PRELIMINARY OVERALL AREA DEVELOPMENT PLAN FOR LA CANTERA

RE: Revised La Canterra Subdivision POADP #237

The City Staff Development Review Committee has reviewed your La Canterra Subdivision Preliminary Overall Area Development Plan #237. However, your plan was not accepted for the following reasons:

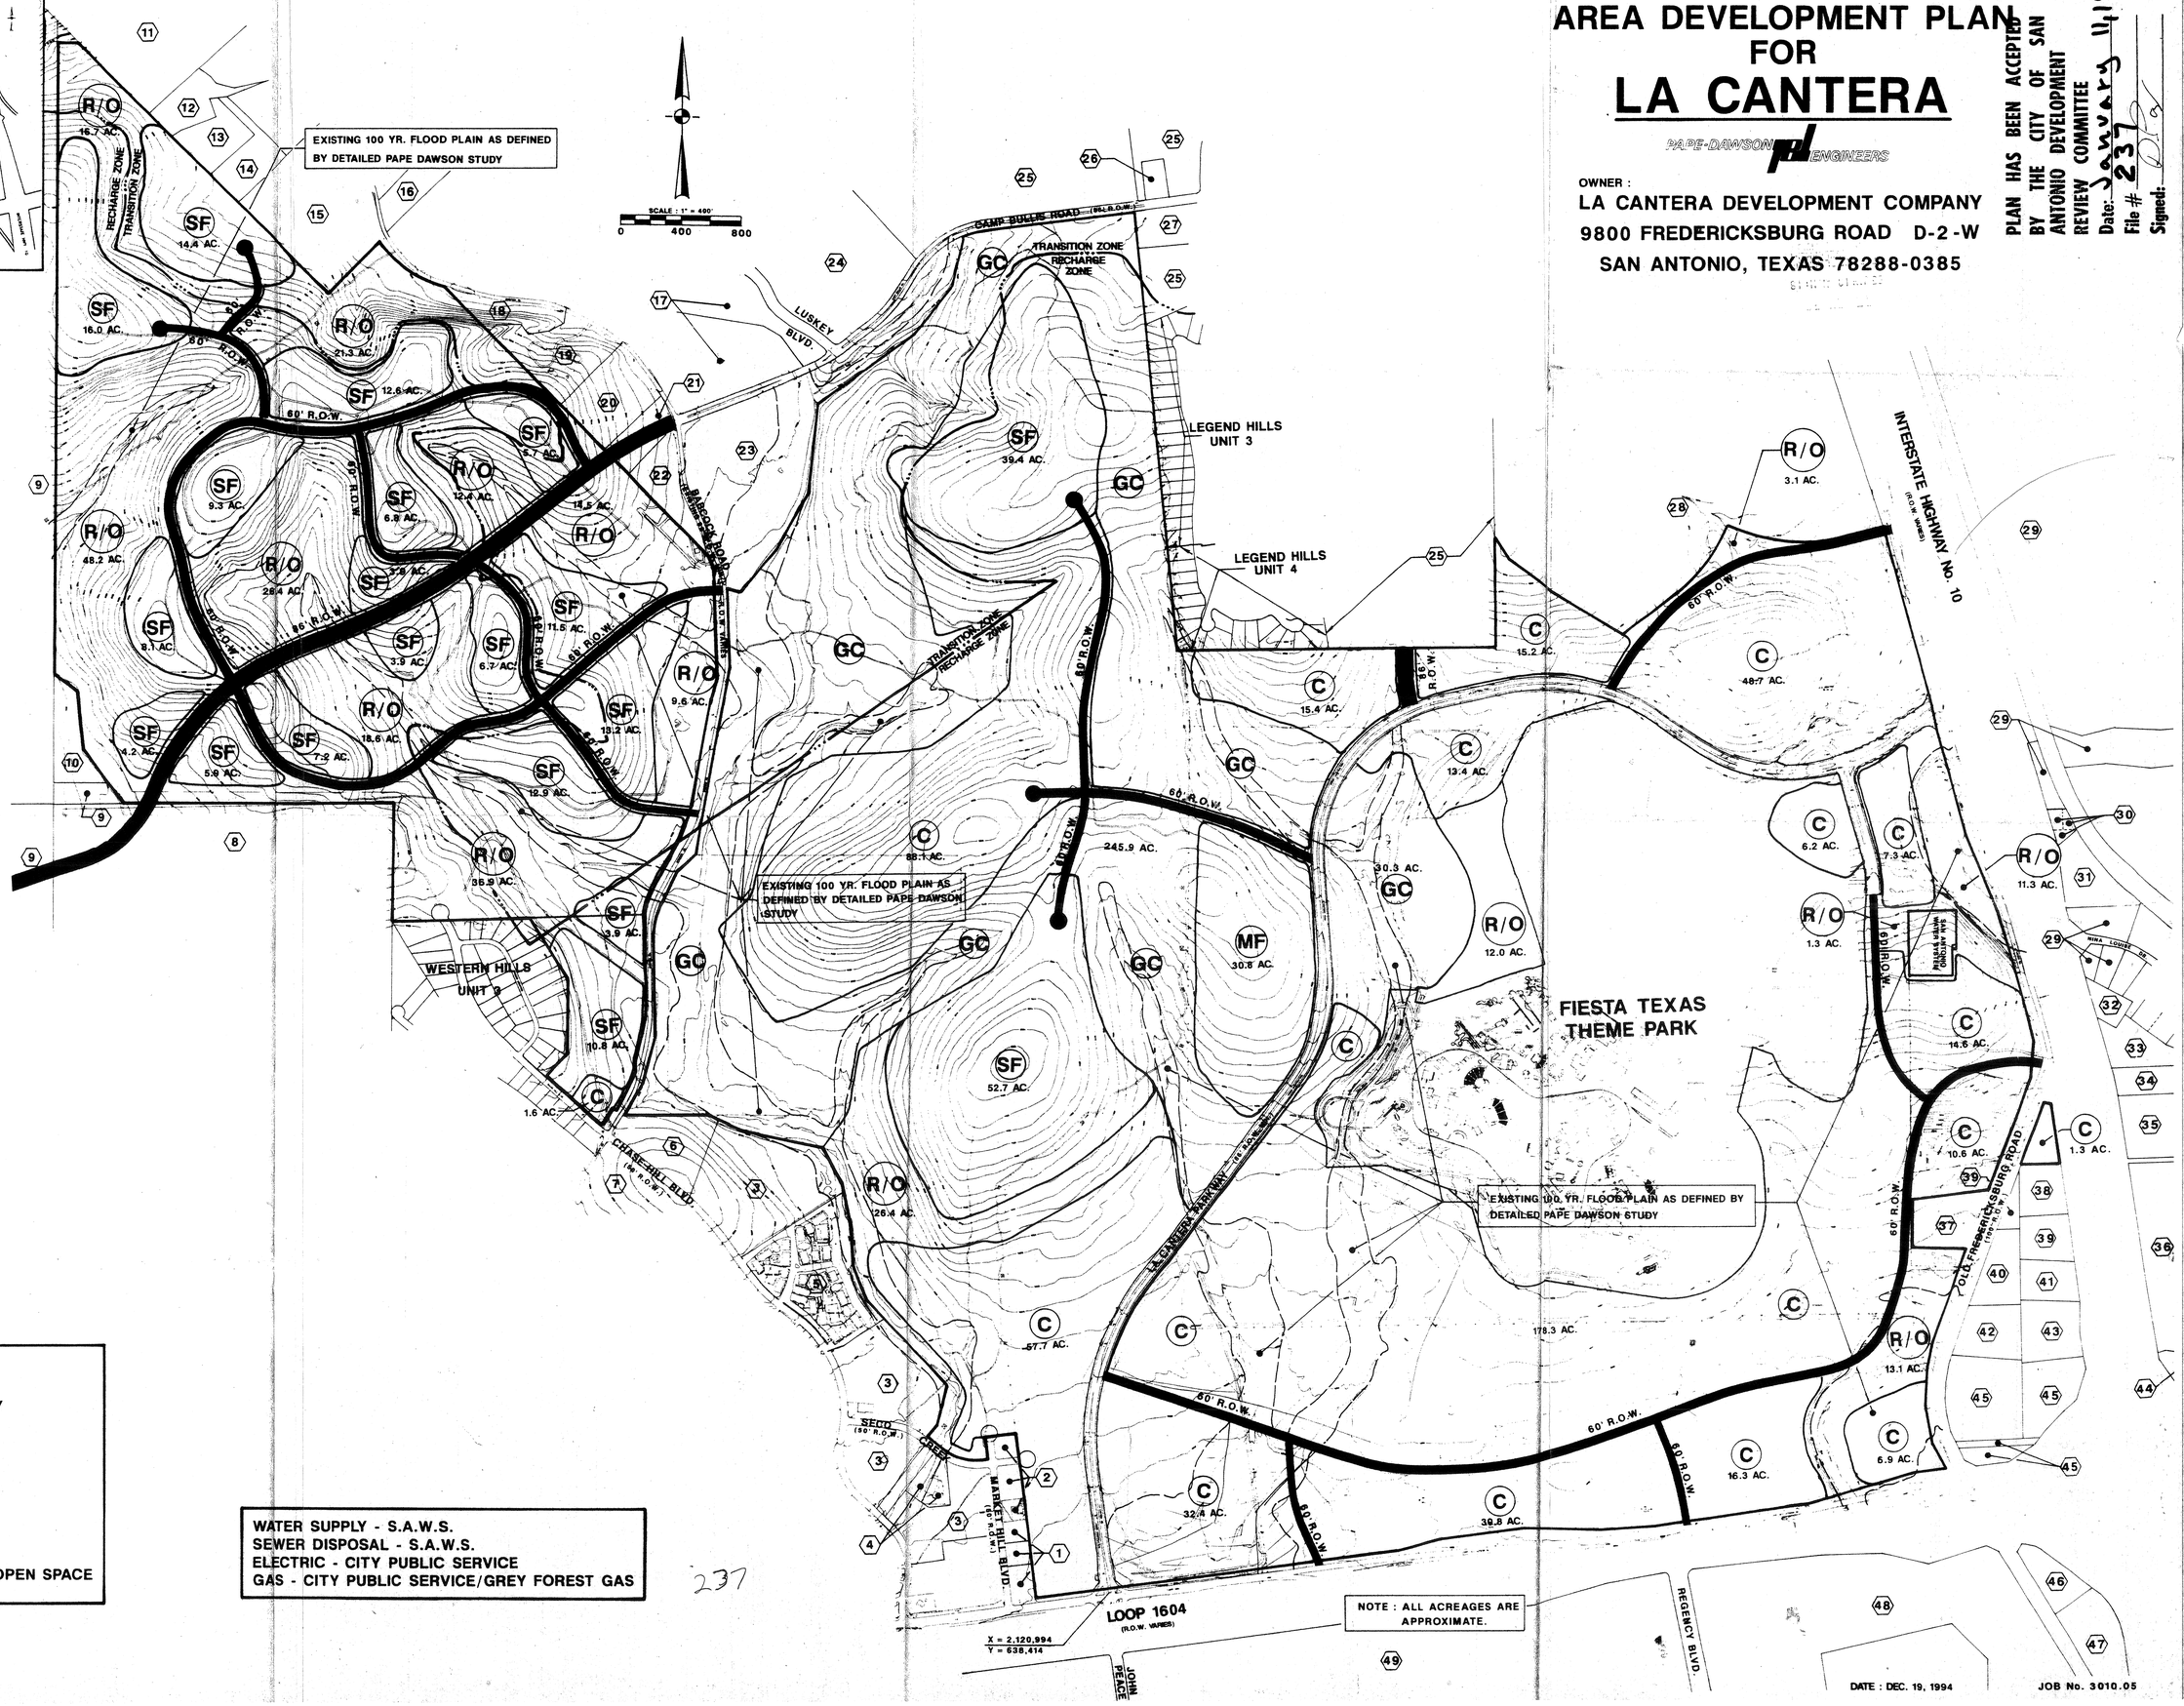
1. All the proposed "50 foot ROWs" east of La Cantera Parkway need to be 60 foot ROWs (local "B" or collectors).

2. Seco Creek, Market Hill Blvd., and Chase Hill Blvd. need to be extended into your development.

3. Babcock Road needs a minimum ROW width.

4. Dedication needs to be provided along both sides of Babcock Road to bring it up to 86 feet (43 feet from centerline).

5. The proposed 50 foot ROW extending westerly needs to be a 60 foot collector (50 foot locals need to feed into 60 foot collectors, not 86 foot arterials/"Hierarchy of streets").

6. The 86 foot to a 110 foot non-exclusive access easement needs to be removed from the plan or shown as either a proposed public or private ROW.

119.204 ACRES
EASEMENT
LA CANTERA PKWY
IH-10

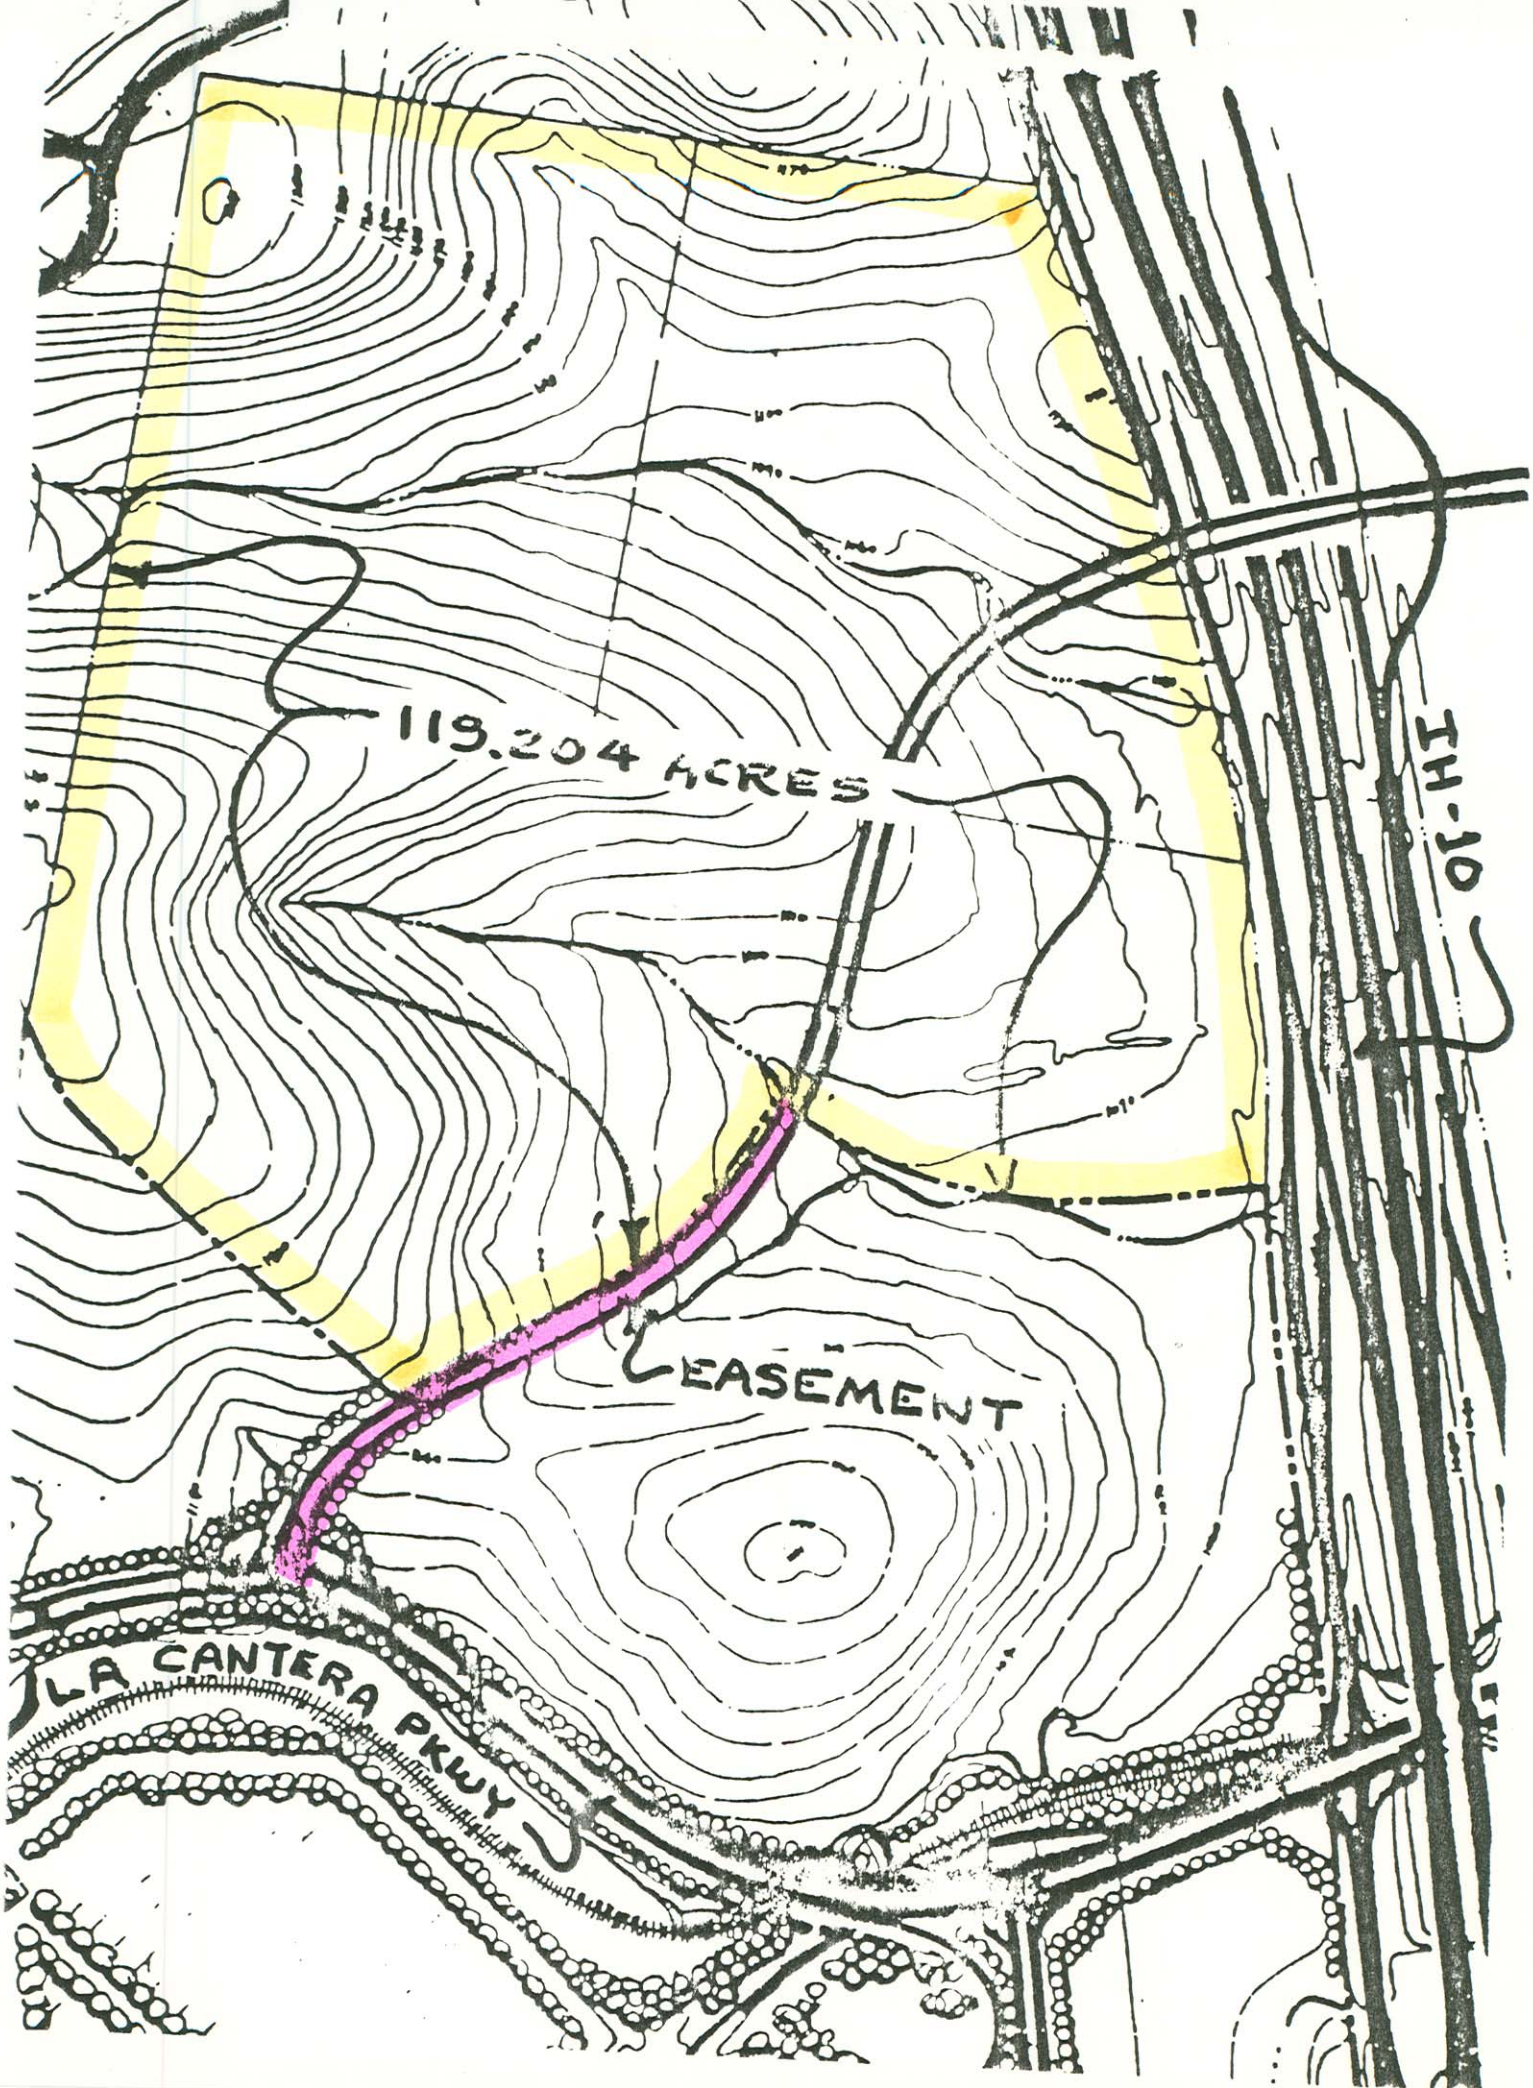
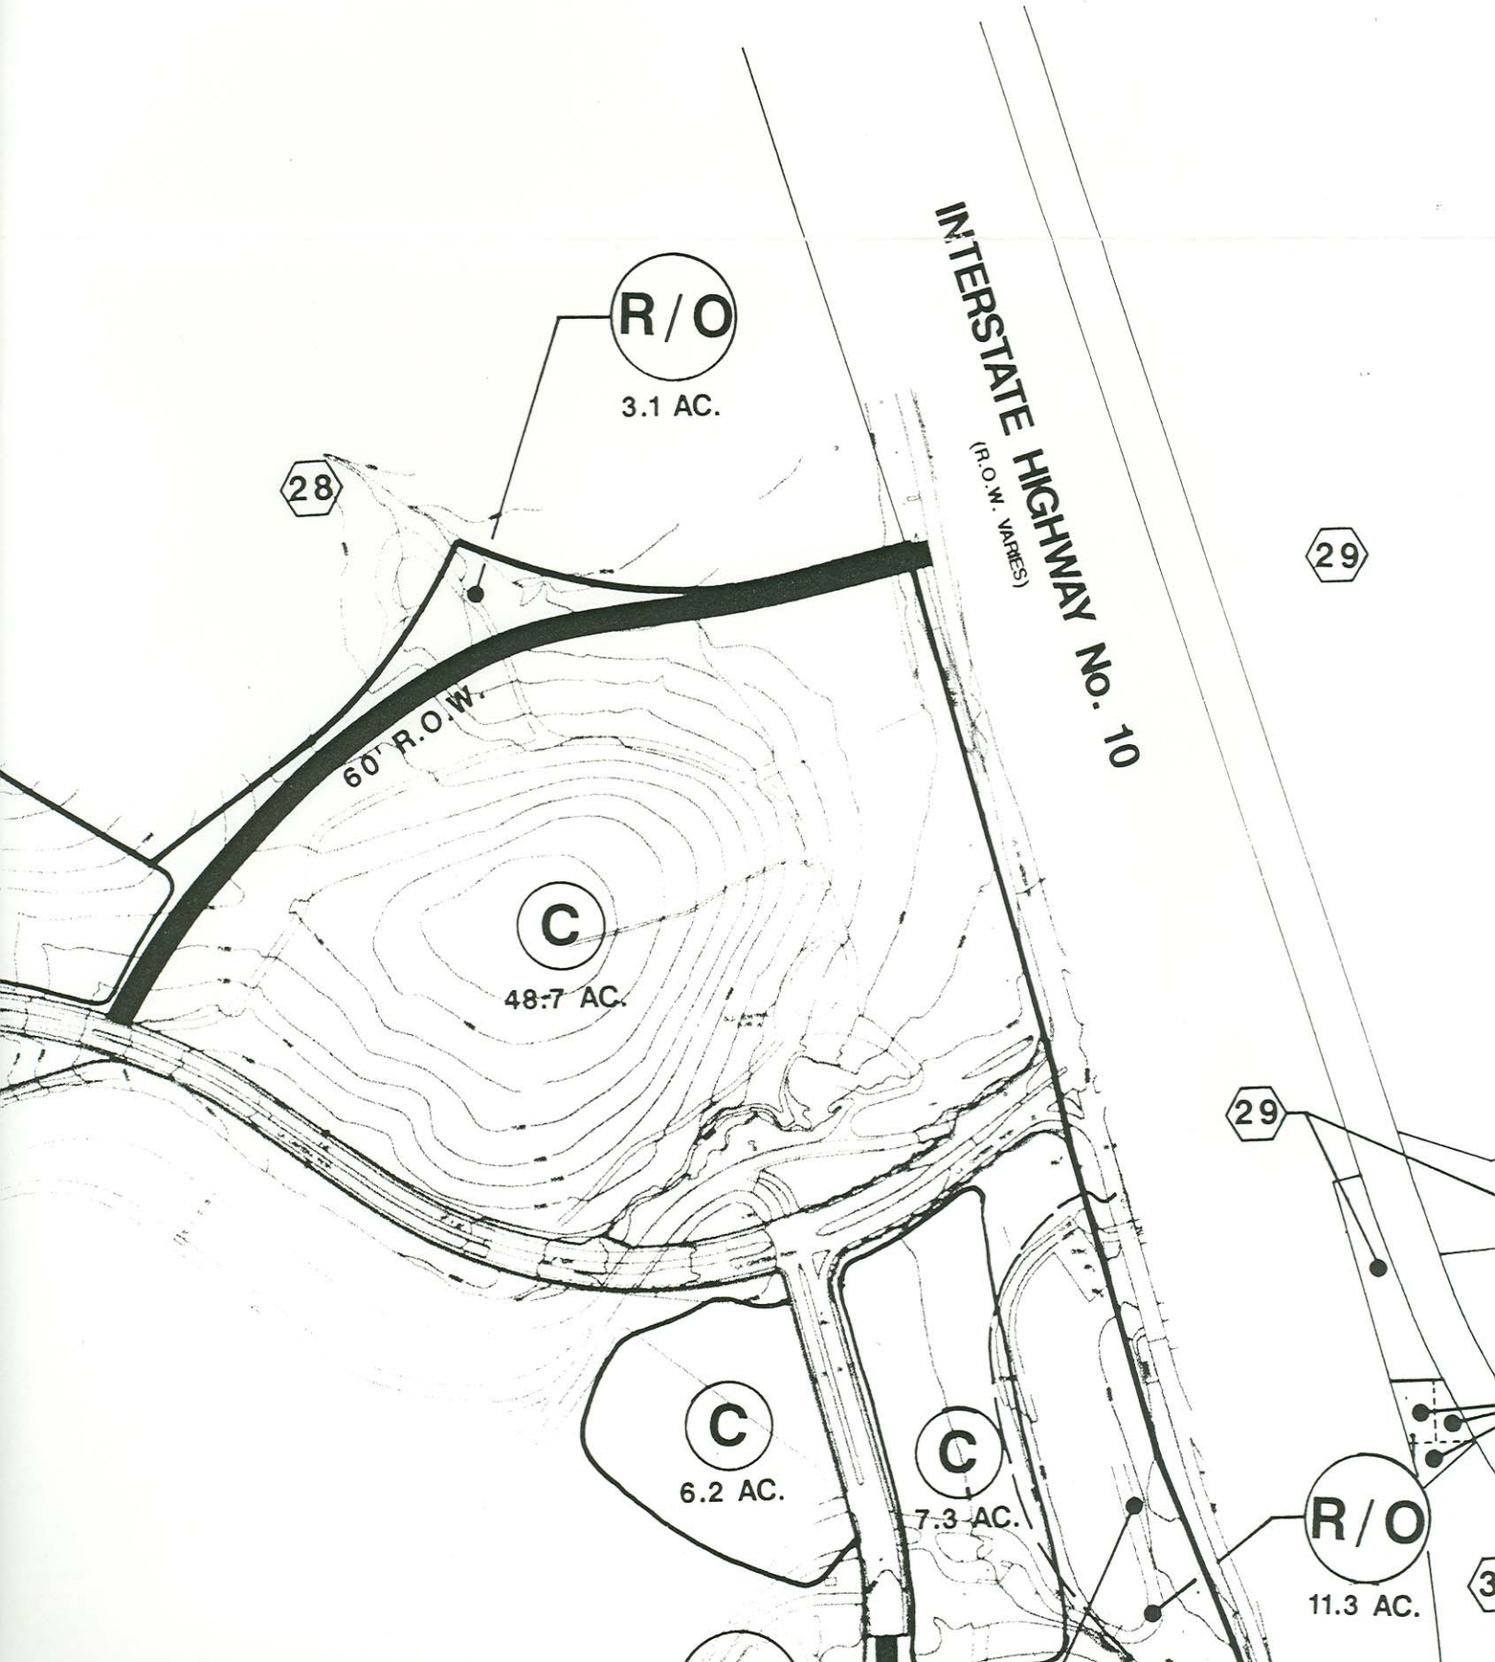
The parcel referenced above is depicted on a drawing accompanying this letter, the perimeter of which parcel is highlighted. It is connected to La Cantera Parkway by a 60 foot wide access easement, also highlighted, which easement was granted to James P. McDonough, Jr. (owner of the referenced parcel) by La Cantera Development Company (owner of the host parcel) and recorded in the Official Public Records of Real Property of Bexar County, Texas (Vol. 5973, Pages 1005-1037) on Febraury 24, 1994. A plan of said easement also accompanies this letter.

On January 11, 1995, a Preliminary Overall Area Development Plan for La Cantera was accepted by the City of San Antonio Development Review Committee (Planning Department File #237). A copy of a the portion of that plan in the area of present concern also accompanies this letter.

Referring to the plan referenced in the preceeding paragraph, we direct your attention to the location of the 60 foot wide right-of-way running in a generally northeasterly direction from station ca. 24+74 on La Cantera Parkway to a point on the west side access road of Interstate Highway 10 approximately 1,200 feet north of the latter's intersection with La Cantera Parkway. It will be noted that the proposed layout of said right-of-way is such that the access to La Cantera Parkway afforded along a substantial portion of the southern boundary of the referenced 119 acre parcel, access granted by La Cantera to Mr. McDonough via the easement in 1994, would be eliminated in its entirety by virtue of the layout of the right-of-way and the consequential 3.1 acres of recreational/open space intended to exist between said right-of-way and the 119 acre parcel, as proposeded by La Cantera in 1995.

It may be that the City may not have been aware of the existence of the prior easement, being that it is so conspiculously absent from the POADP. One purpose of this letter, therefore, is to bring this apparent dichotomy to the attention of planning authorities of the City of San Antonio, in order that the easement's existence may be taken into account when the host parcel it traverses is considered for development. The primary purpose of this letter, however, is to request a determination from the City as to what extent, if at all, the easement rights secured by Mr. McDonough may have been abrogated by virtue of the Development Review Committee's approval of the POADP.

Staff consensus that the acceptance of the La Cantera POADP does not impact the previous agreement that was reached between Mr. James P. McDonough Jr. and the La Cantera Development Company. The access issues should be resolved amongst the parties involved.

Please note that an approved POADP does not include an actual survey engineering dimensions or easement rights. That information will be required at the time of platting. At that point, any platting will have to comply with the Unified Development Code at the time of plat submittal.
